Reference: 92201802-FA

Urgent Field Safety Notice - Important Medical Device Information
Capio™ Suture Capturing Devices (SLIM, Standard, Open Access, RP)
Uphold LITE with Capio™ SLIM Vaginal Support System
Pinnacle™ Anterior Pelvic Floor Repair Kit
Pinnacle LITE Posterior with Capio SLIM Pelvic Floor Repair Kit

Root Cause Investigation:

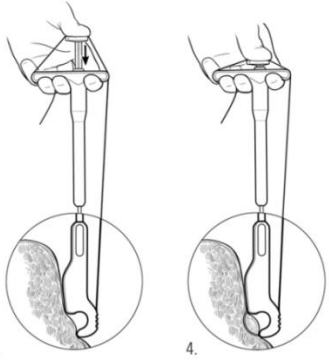
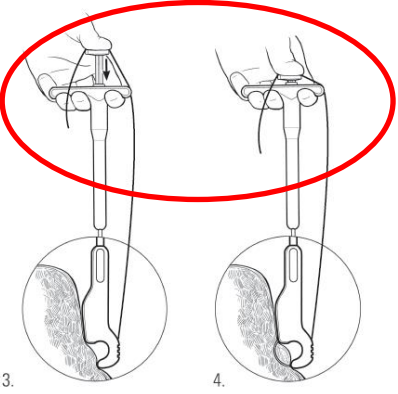
If the Capio suture or pelvic floor kit mesh assembly is placed under excessive counter-traction during deployment, it can result in an interaction between the suture and the Capio carrier that could potentially damage the suture and may cause the dart to detach. The testing confirmed that higher amounts of counter-traction (tension) placed on the Capio suture or pelvic floor kit mesh assembly during deployment contributes to an increased likelihood of damage to the Capio suture and potential Capio dart detachment.

Our Quality and Research and Development team is continuing their investigation to determine if potential design changes will help mitigate this risk. In the interim, BSC recommends the following technique for Capiro use.
